ST. JOHNS RIVER WATER MANAGEMENT DISTRICT
ENVIRONMENTAL RESOURCE PERMIT #40-069-114354-1
RAI Submittal

HARTWOOD MARSH ROAD
PHASE II

**Re: Hartwood Marsh Road—Phase II
1500 feet East of Hancock Road to Orange County Line
Application Number 40-069-114354-1
Response to Request for Additional Information**

HARTWOOD MARSH ROAD – PHASE II 1500 FEET EAST OF HANCOCK ROAD TO COUNTY LINE DRAINAGE CALCULATIONS

FLOOD PLAIN COMPENSATION
BASIN 5

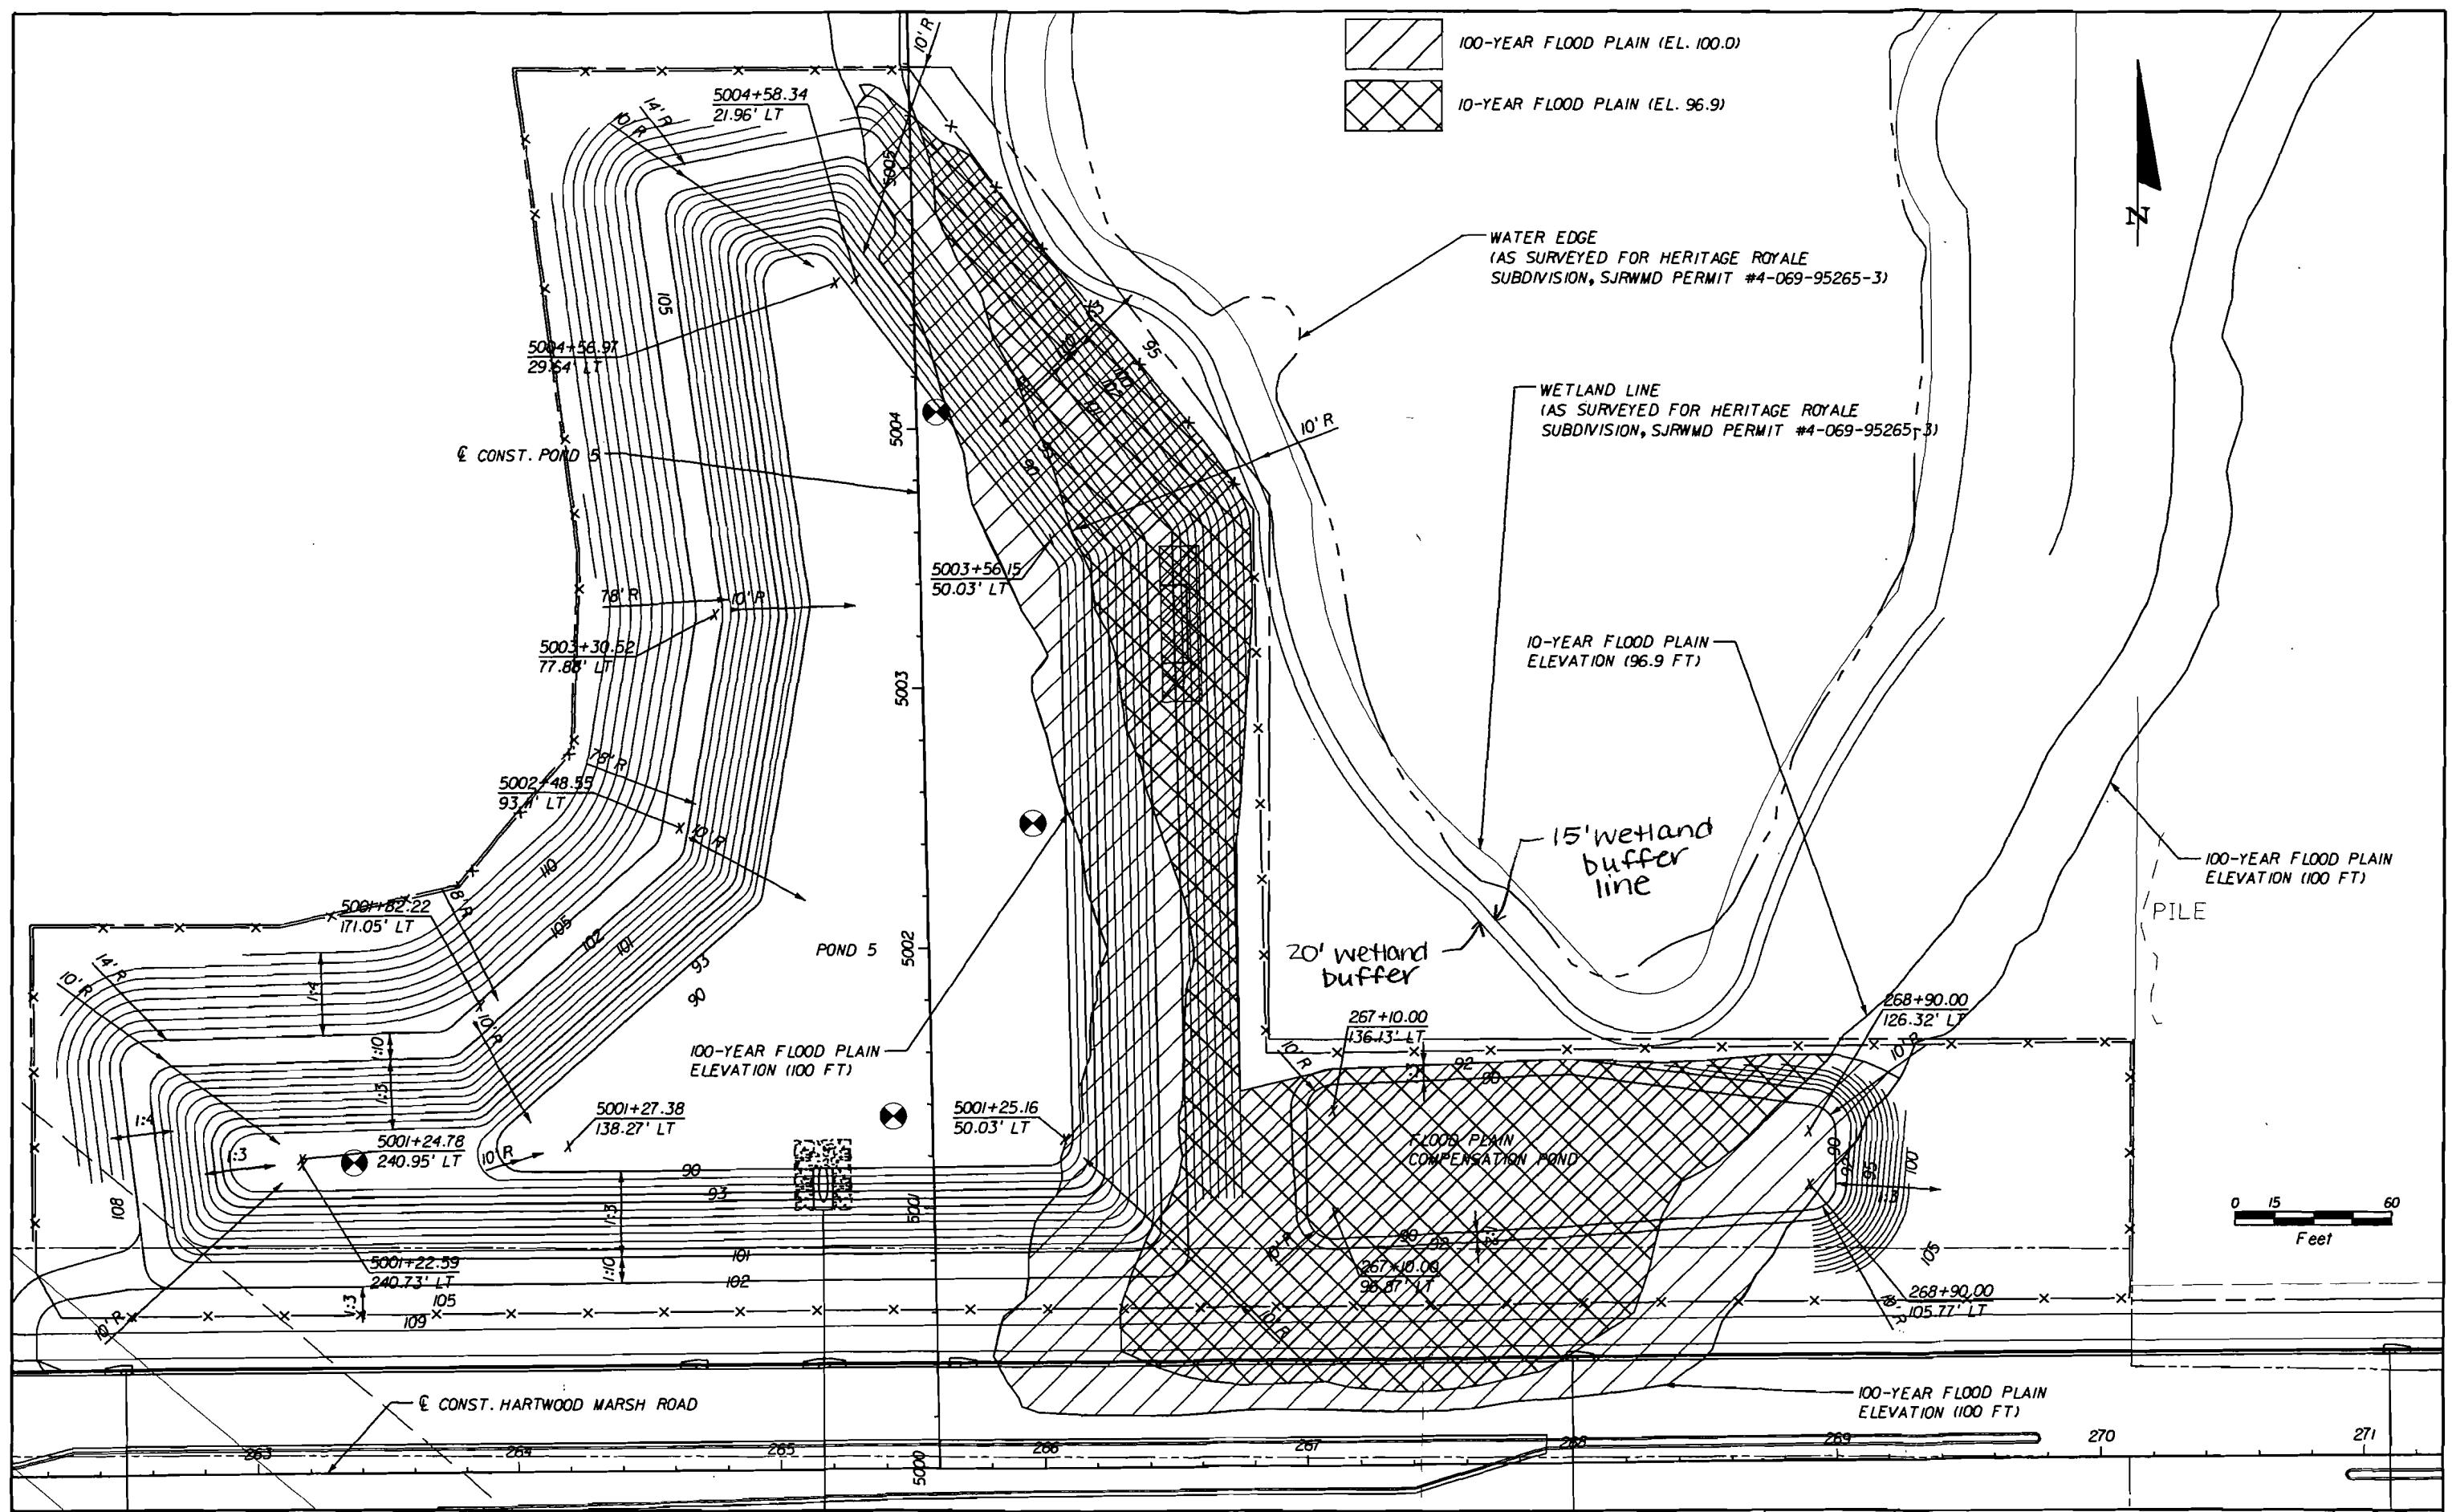
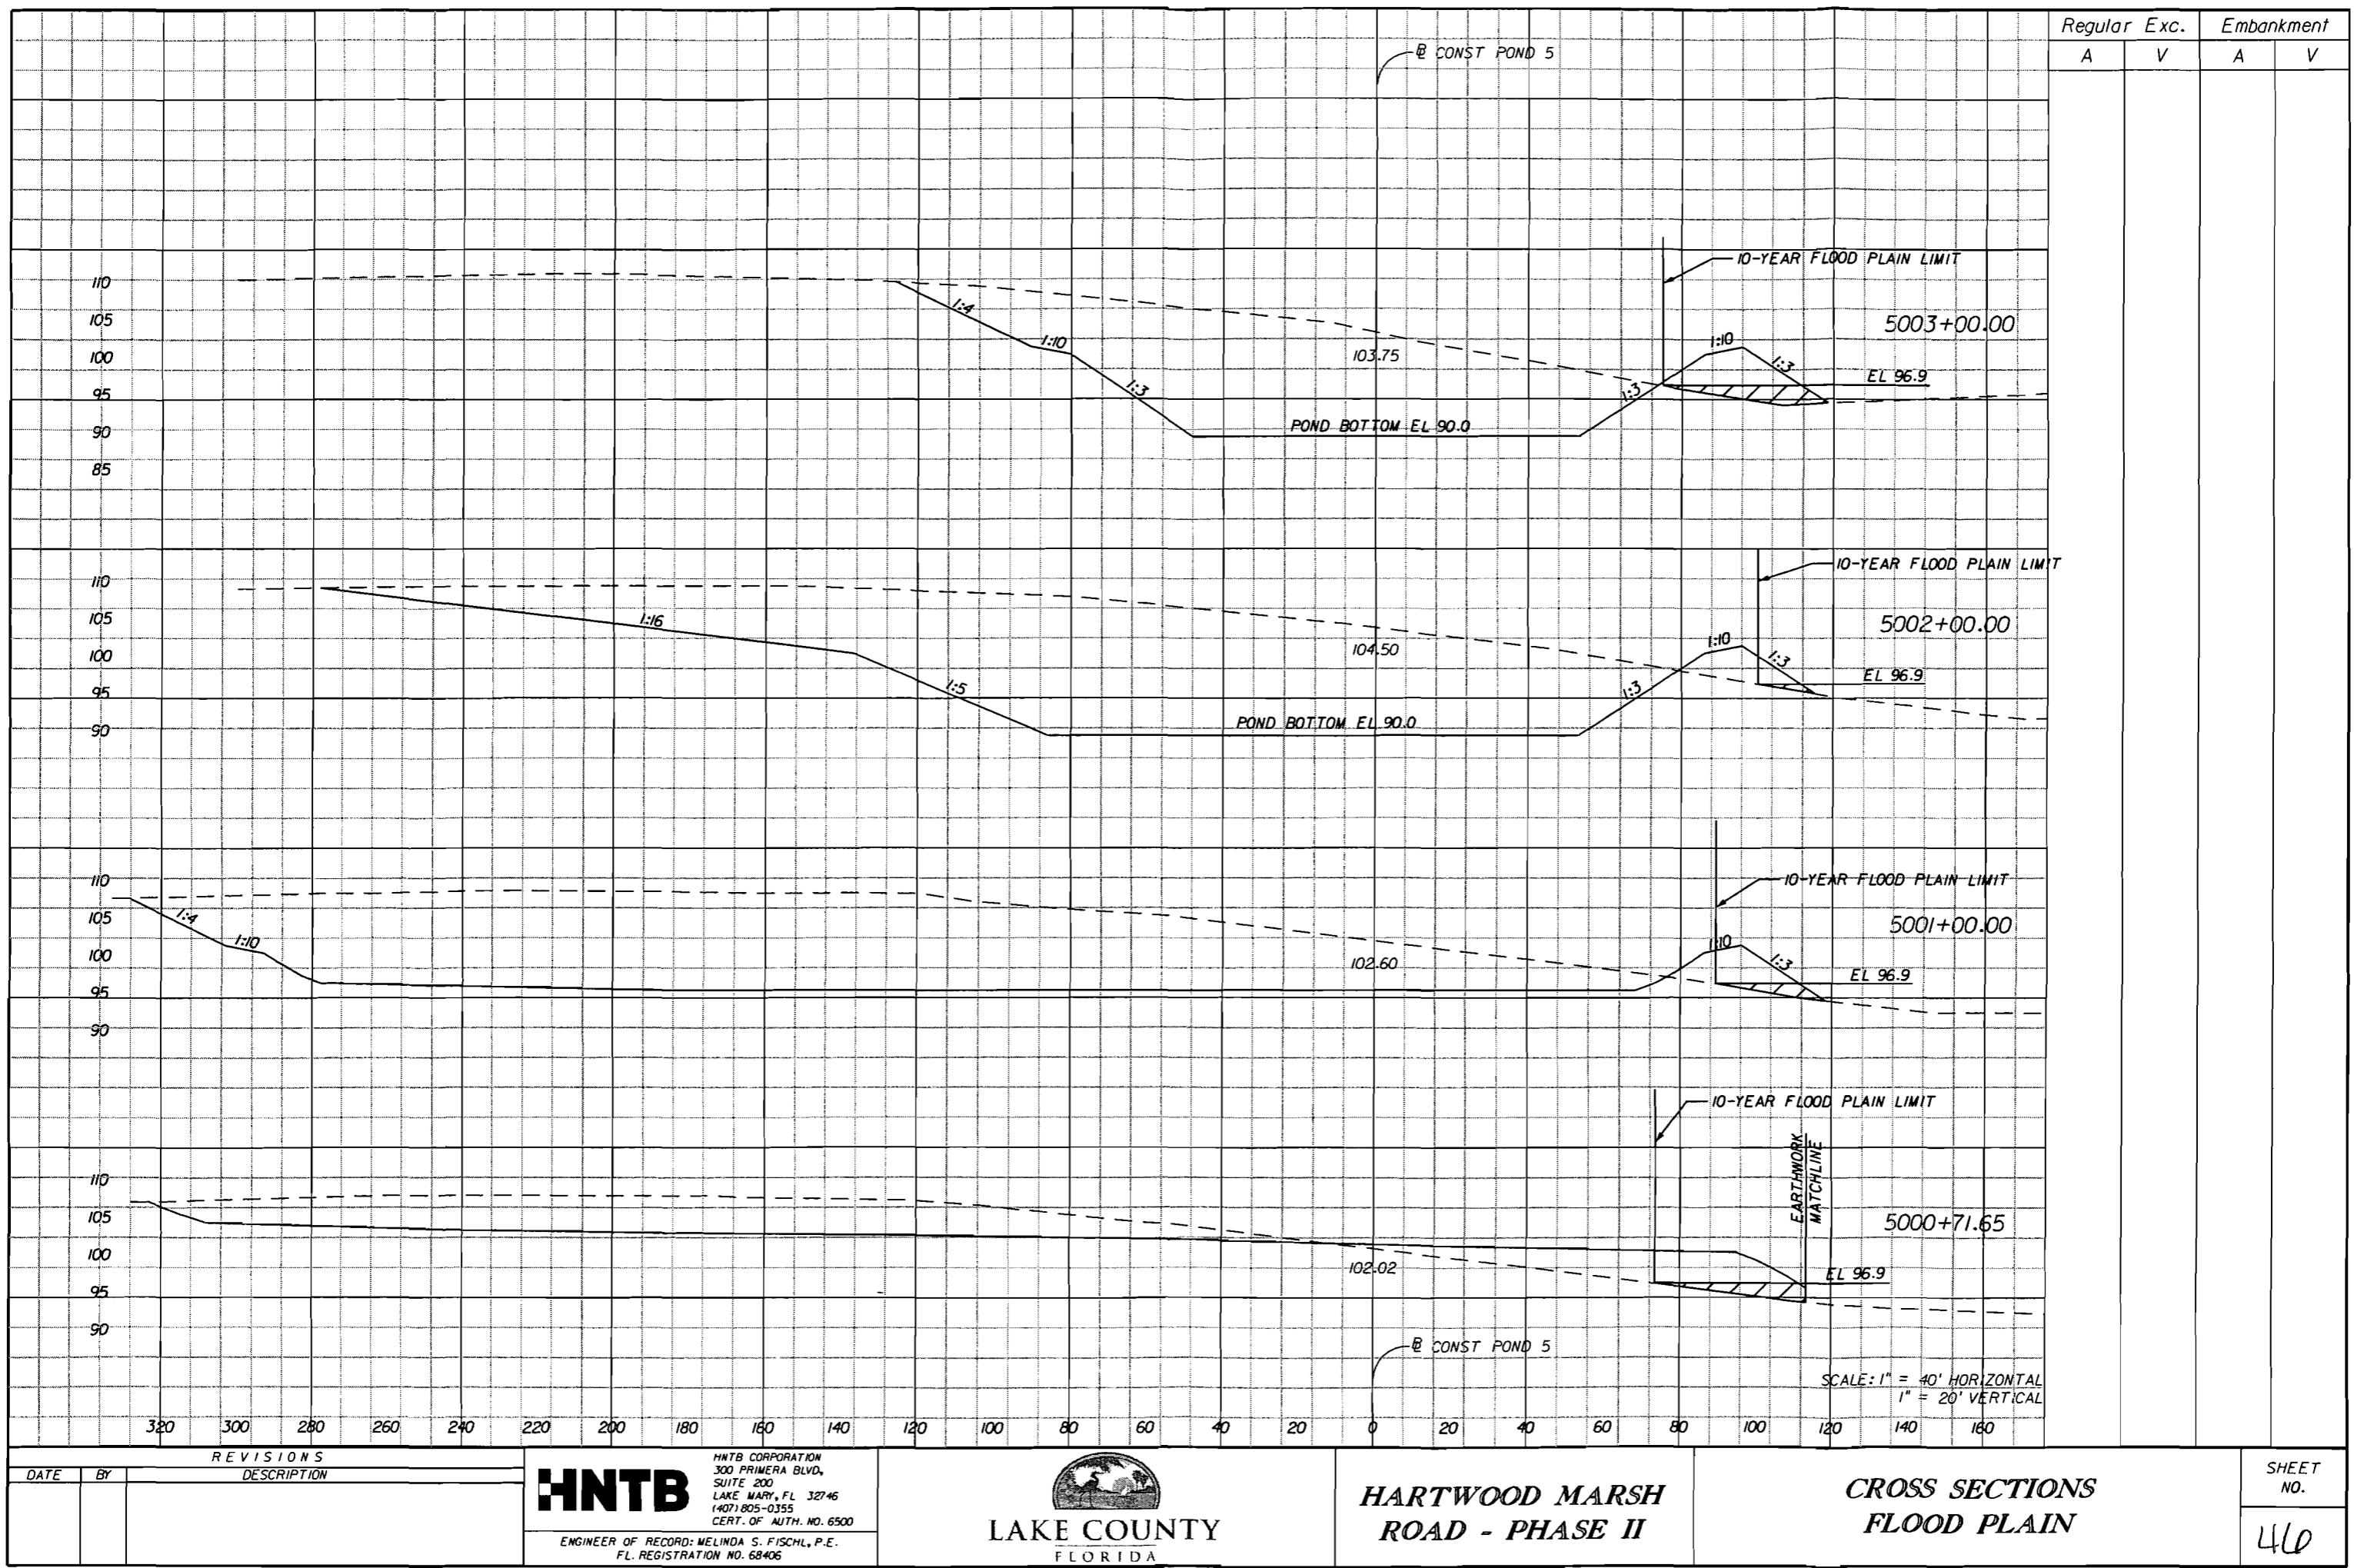
- c. The construction of a portion of the road and Pond 5 within Basin 5 will require the placement of fill in the 100-year flood plain for John's Lake. Insufficient information was provided; however, to determine whether impacts to the 10-year floodplain will occur and whether compensating storage will be needed. Accordingly, please provide additional calculations and/or documentation demonstrating that the proposed work will not cause a net reduction in flood storage within the 10-year flood plain pursuant to Section 10.5, Applicant's Handbook: Management and Storage of Surface Waters (A.H.: MSSW).

- Response:**
- a. *The stage-area input parameters in PONDS has been corrected. Please refer to the revised recovery calculations in the Appendix.*
 - b. *The volume for the 25-year/96-hour storm is 13.40 ac-ft. Please refer to the Hydrology Time Series report in the ICPR section of the Appendix for Pond 5. The back-to-back storms were run for Pond 5 and the pond will not overtop. Please refer to the stage-storage-volume sheet in the Appendix for Pond 5.*
 - c. *The 10-year floodplain calculations and cross sections have been included in the revised calculations in the Appendix. The amount of fill is less than the amount of excavation for the 100-year and 10-year; therefore, there is no net reduction in flood storage area for either storm. Please refer to the 10-year floodplain calculations in the Appendix for Pond 5 as well as the revised cross-sections for the 10-year floodplain.*
